PCO #003

Project: 21-501 - Collin County Adult Detention Facility, Phase 1 Addition
 4300 Community Avenue
 McKinney, Texas 75071

Prime Contract Potential Change Order #003: PR # 1 - Civil, Structural, Arch Changes

Provide for additional work required to complete all work associated in PR # 1 dated February 17, 2022.

DOOR SCHEDULE, DOOR TYPES, & FRAME ELEVATIONS

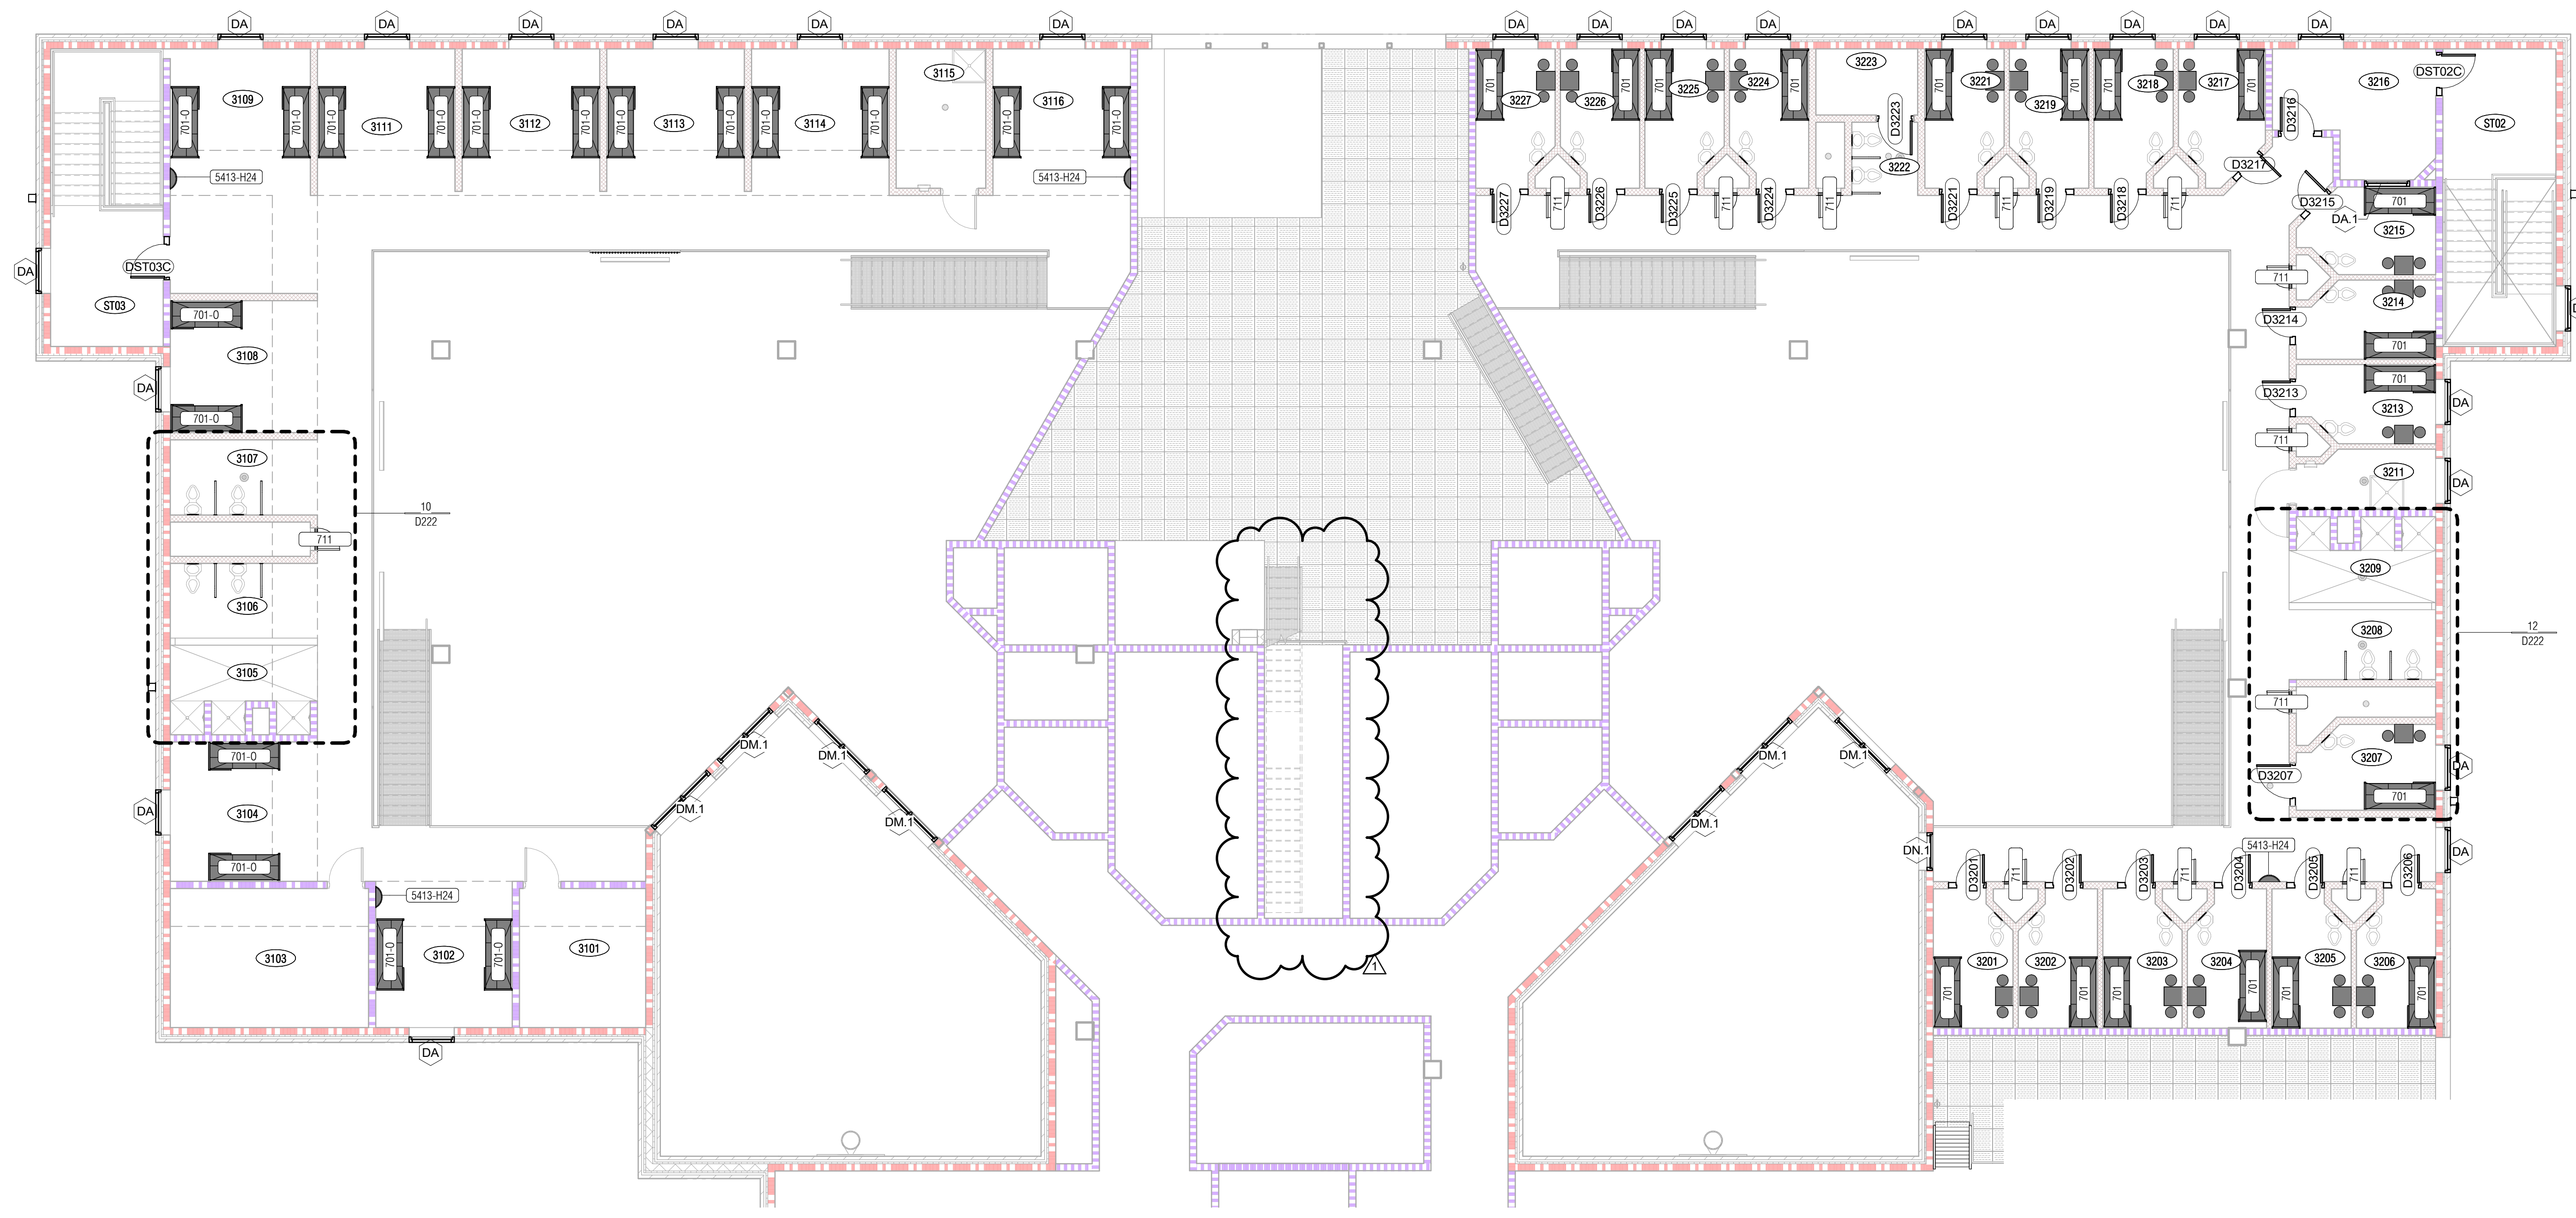
- Item No. 3. Per submittal review of precast walls, pier locating dimensions, top of pier, and grade beam dimensions were modified
- Item No. 4. Revise the size of door frames 'AA' and 'AC' frames to course with masonry. Doors 1136, 1139, and 1140: Change door sizes from 7'-2" to 7'-0" so the 4" heads course with the masonry. Refer to Arch drawings for these changes.
